**Re: Review of VHB Report
Intersection at Atlantic Ave/Prospect St./Surfside Rd/Sparks Ave. ('Four Corners')
Nantucket, Massachusetts
Our Project Number: 09903**

INTRODUCTION

Ourston Roundabout Engineering (ORE) has completed a review of the intersection evaluation of Atlantic Avenue, Prospect Street, Surfside Road and Sparks Avenue ('Four Corners') that was completed by Vanasse Hangen Brustlin (VHB) on June 23, 2008. The tasks which we were to undertake form the headings of the following technical report, namely:

Figure 1: Alternative #2 Deficiencies

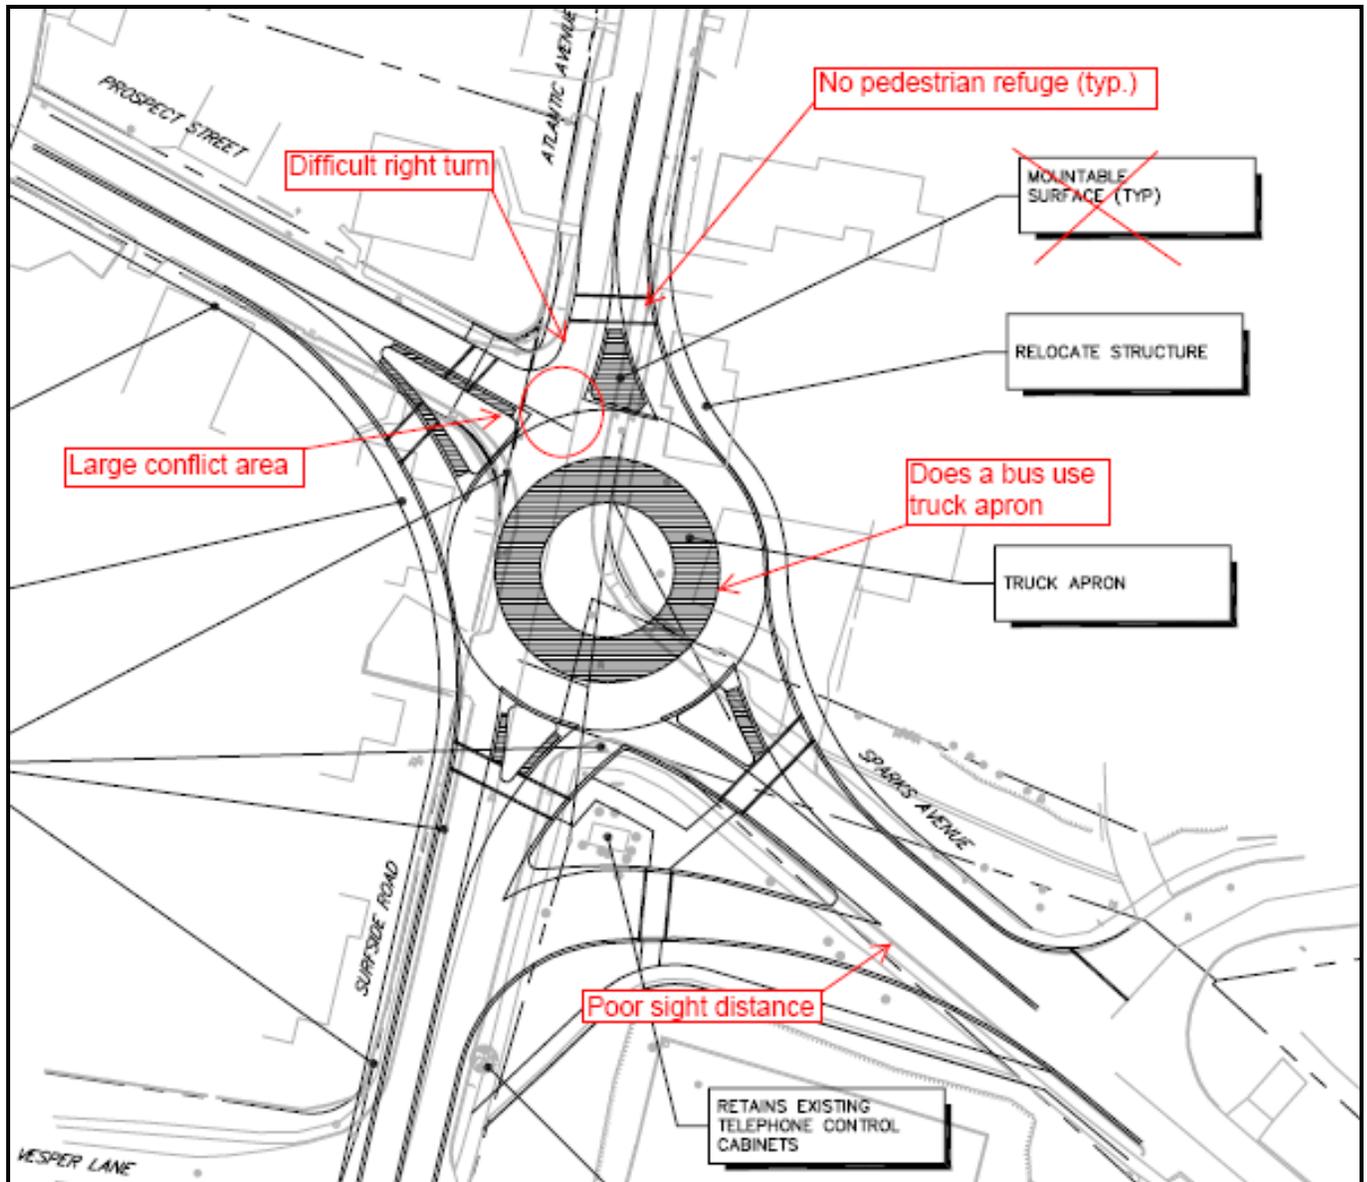
- Alternative 1 provides slightly improved pedestrian accommodations and space for larger trucks. Depending on the number of large trucks expected, Alternative 1 is preferred.
- The vehicle paths for entering the roundabout are similar but Alternative 1 has more circulating space for EB left turn movements to conflict with SB movements in the circulating roadway. Some SB right turners may not yield for this reason. Therefore a larger circle should have better definition of entry paths. This can be achieved using the splitter island curve and entry widths to develop straighter-in entry paths.
- Consider maintaining a raised median on Atlantic Avenue. The occasional right turning truck can go around the roundabout to go WB on Prospect Street by turning 270 degrees. Alternatively, consider relaxing the SB right turn path using a wider exit with a narrower splitter island.

- The Surfside bypass lane has potential conflicts with traffic yielding to EB traffic on Sparks Avenue. The yielding drivers have poor sight of the traffic that has to merge with them. Consider using a similar design to the right turn bypass lane from Alternative 3, this will improve the sight distance of the EB traffic.

- With Alternative 1 there is a possible conflict with "inside truck apron" on SB Atlantic Avenue and pedestrians. Truck blisters, as we call them, are a sign of a weak layout and should be avoided because pedestrians may consider this a pedestrian refuge and mistakenly assume that they are out of the way of traffic. Truck drivers have run over pedestrians with this type of design.

- Can a bus maneuver in the roundabout without using the central island? We typically avoid having a bus use the truck apron to avoid passenger discomfort. There may be the need to increase circulating width to accommodate buses.

- It does not appear possible for a WB-50 truck to make the right turn from SB Atlantic to WB Prospect Street. The occasional right turning truck could go around the roundabout to go WB on Prospect Street turning through 270 degrees.

Figure 2

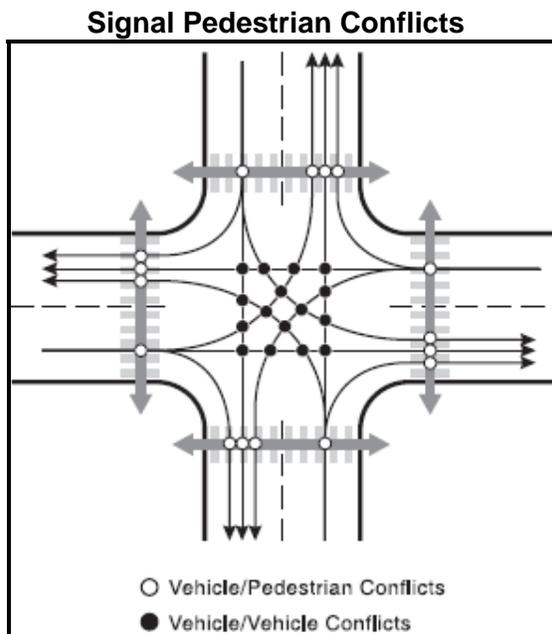
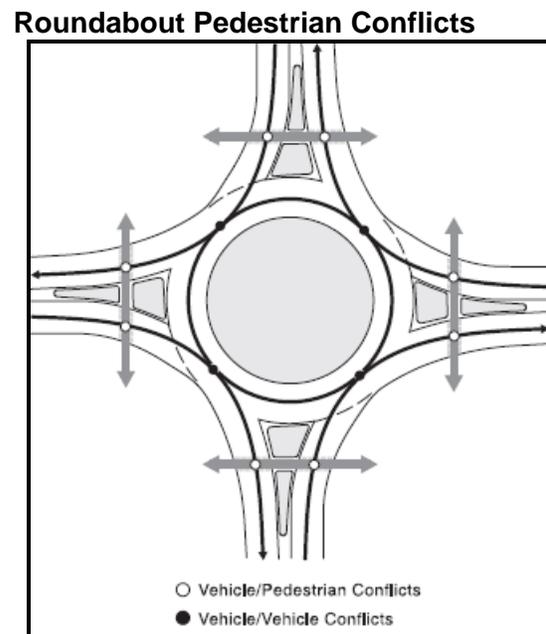
With the proximity of the school and hospital, pedestrian conflicts will need to be kept to a minimum. A roundabout does reduce the number of vehicular and pedestrian conflicts from 16 to 8, (see Figure 2 and Figure 3). At any roundabout it is desirable to have a refuge in the splitter island. This allows for a two staged crossing for pedestrians, pedestrians will only have to look for traffic in one direction. An advantage or disadvantage to a roundabout is that it requires the pedestrians to verify their own gaps instead of having protected phasing. It has been argued that this is a benefit because it keeps pedestrians vigilant. Although traffic regulations require drivers to yield to pedestrian traffic in the crosswalks, a roundabout can be very difficult for younger pedestrians and pedestrians with a visual impairment. In this case, due to the children walking to the nearby school, a crossing guard may be required.

Figure 4: ORE Option 1 – Modern Roundabout

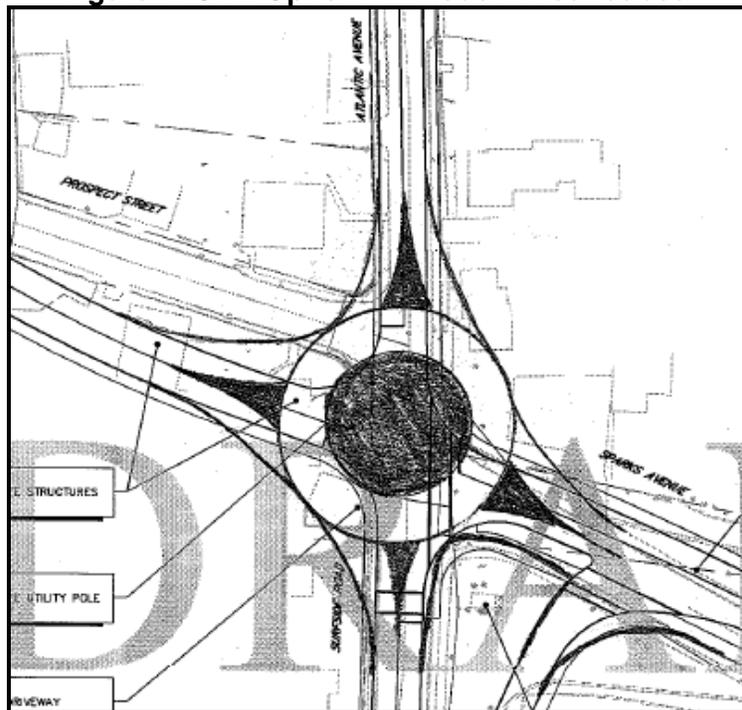
This option uses a roundabout in the VHB's Alternative 3 foot print, see Figure 4. The Alternative 3 design realigns the Prospect Street leg to the south and by squaring the alignment the following benefits are achievable:

- Balancing of entry paths of all four legs of the roundabout;
- Allows for better deflection on the Atlantic Avenue entry; and,
- Improves the right turning radius for SB to WB right turns.
- Decreases the conflict area at the Atlantic Avenue entrance.

This alternative will have a higher right-of-way cost, possible house relocations, but it is an improvement on Alternative 1 and Alternative 2 horizontal geometrics.

Figure 5: ORE Option 2a – Mini Roundabouts

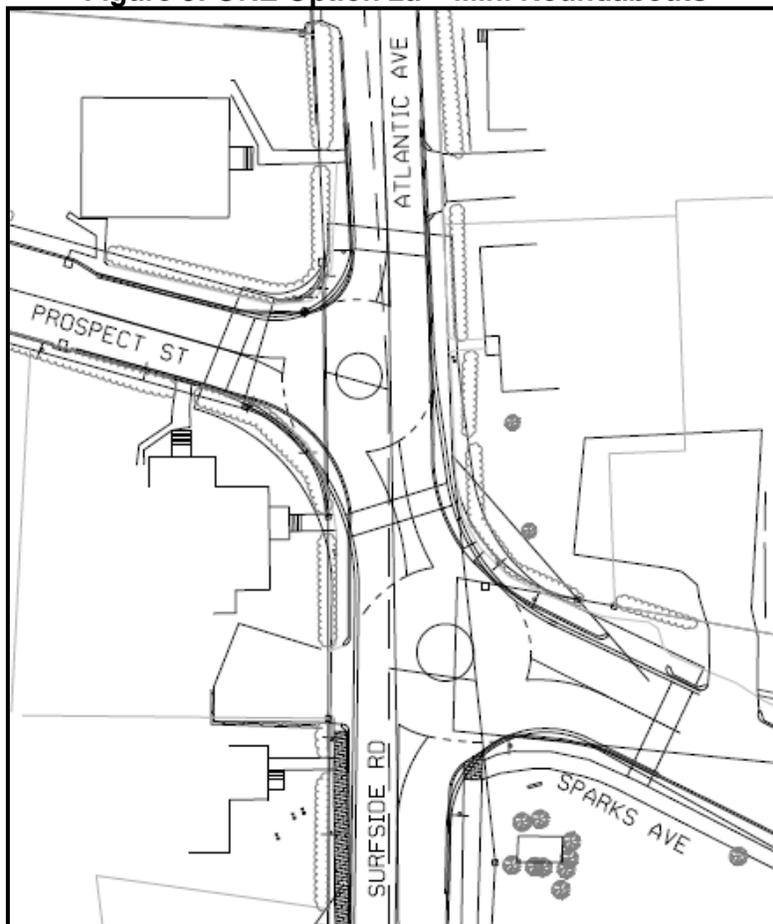
This option utilizes a pair of roundabouts at the Four Corner's intersection, see figure 5. The mini roundabouts will utilize the existing intersection with minor curb adjustments which minimizes right-of-way impacts and home acquisitions. The savings in construction and right of way cost could contribute to the construction of a modern roundabout at the Surfside Road and Vesper Lane intersection opposite the high school driveway. Although we are not aware of the safety and capacity performance of this intersection, knowing the access requirements and mix of pedestrian and vehicular traffic near schools, this alternative provides multiple benefits.

Mini roundabouts are roundabouts that are used in tight urban settings with approach speeds that are equal to or less than 30 mph and are completely traversable. They have been implemented in Europe, at numerous intersections, with much success. It is a relatively new intersection control device in the United States. Due to the low speed corridor, speed reduction is not required, but the central island should still deflect the entering driver, similar to modern roundabouts. To allow for the

occasional trucks the central and splitter island are traversable. In advance of the roundabout a traversable eliminated bollard is placed to alert drivers of the upcoming mini roundabout.

Due to the cost savings of the mini roundabout option 2b has been proposed. The combined roundabout option will improve the safety of the mini roundabouts and pedestrians in the area by providing a traffic calming effect on the Surfside NB traffic. The roundabout will reduce speeds and provide pedestrian refuges for pedestrian crosswalks closer to the school. It will also improve the access to and from Vesper Lane and the school parking lot. The mini roundabouts with or without the Surfside Road and Vesper Lane roundabout are both viable options that will need further investigation to confirm the anticipated benefits based on the above mentioned criteria.
